**BIDDING AND CONTRACT DOCUMENTS  
FOR THE  
METROPOLITAN SEWERAGE DISTRICT OF BUNCOMBE COUNTY  
WEAVERVILLE PUMP STATION AND FORCEMAIN SYSTEM IMPROVEMENTS**

**ADDENDUM NO. 1**

**Date Issued: November 27, 2023**

- A. Project Name: Weaverville Pump Station and Force Main Improvements.
- B. Owner: Metropolitan Sewerage District of Buncombe County.
- C. Owner Project Number: 2019080.
- D. Engineer: CDM Smith.
- E. Engineer: Project Number: 265366.
- F. Date of Addendum: 11/27/2023

PROJECT NO. 20176-265366  
FILE NAME: C317FMPP.DWG  
SHEET NO.  
**C-317**

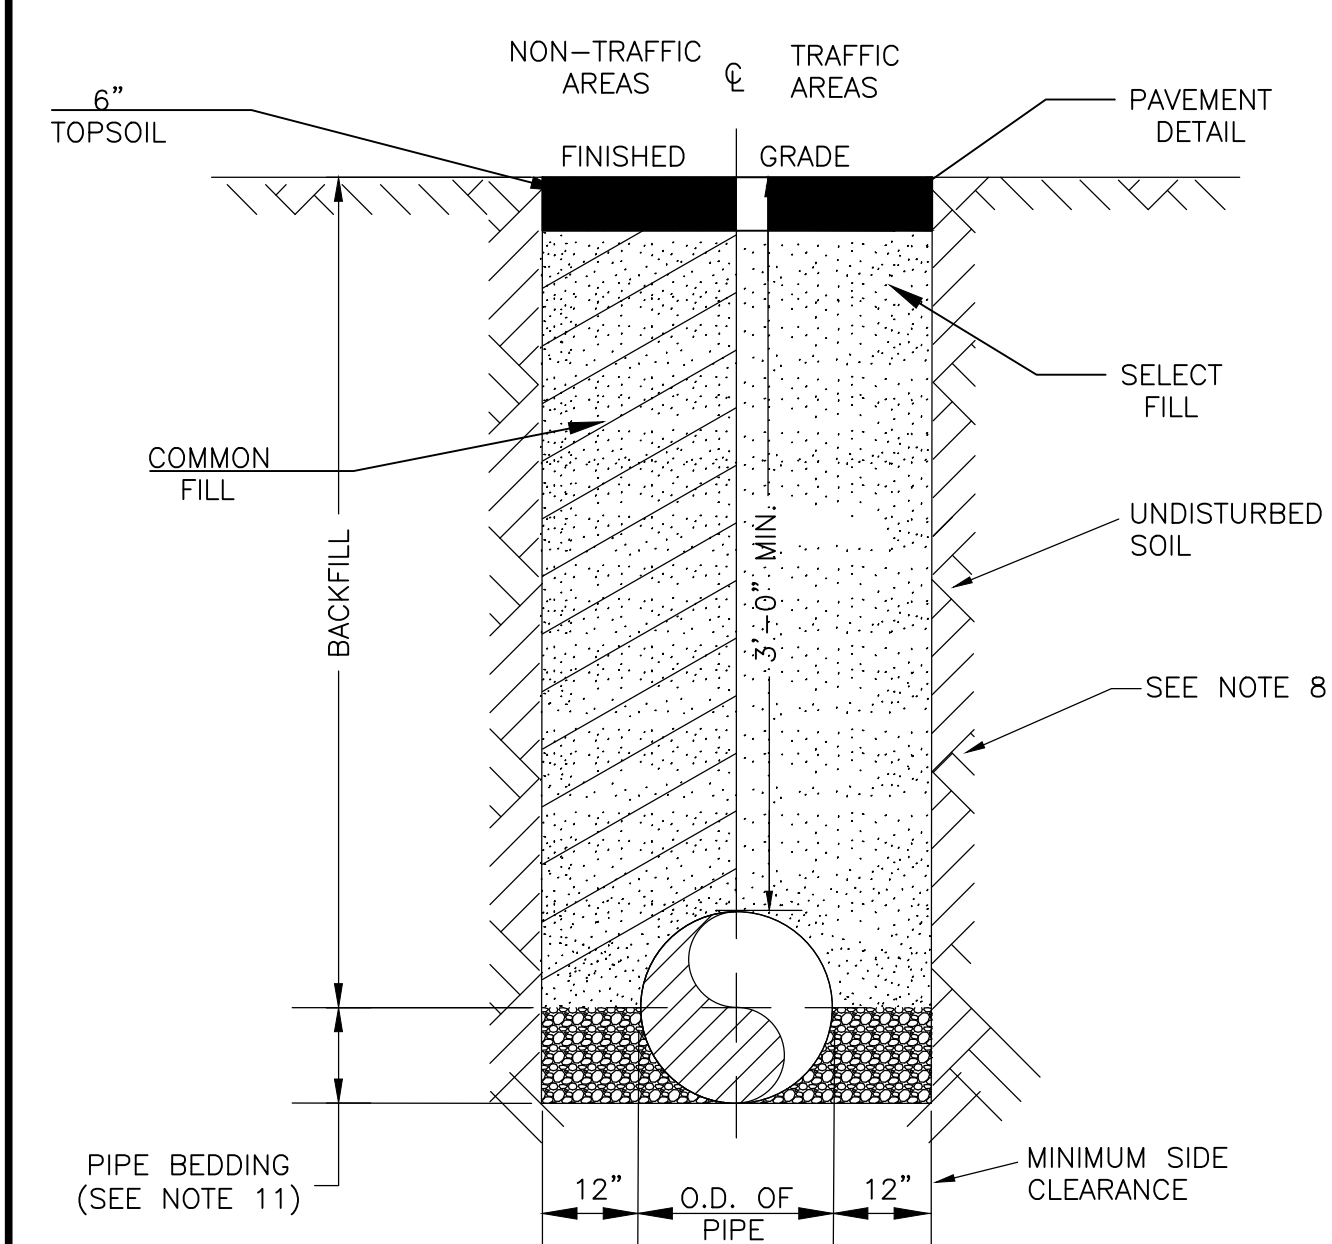
12. QUESTION: Please clarify what the "Hydro Building" is referring to in Bid Form item 21.

This Building is not mentioned anywhere else in the specs or drawings.

RESPONSE: The hydro building is at the southern end of the project coming off Riverside Drive. See plan sheet C-317.

PIPE JACKING DETAIL  
DETAIL B  
NTS

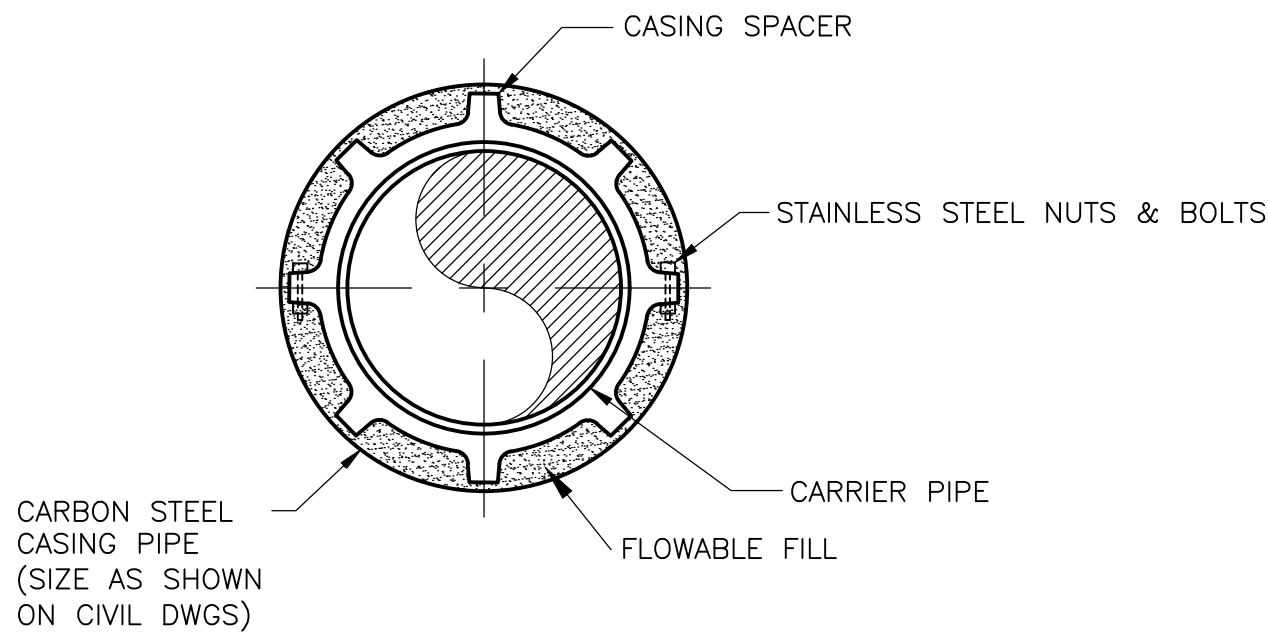
11. QUESTION: Please confirm whether the jack and bore casing needs to be 42" or 36".

Item No. 12 on the bid form currently states "42-inch Casing" and drawing C-302 shows a 36" casing.

RESPONSE: 36" minimum casing size.
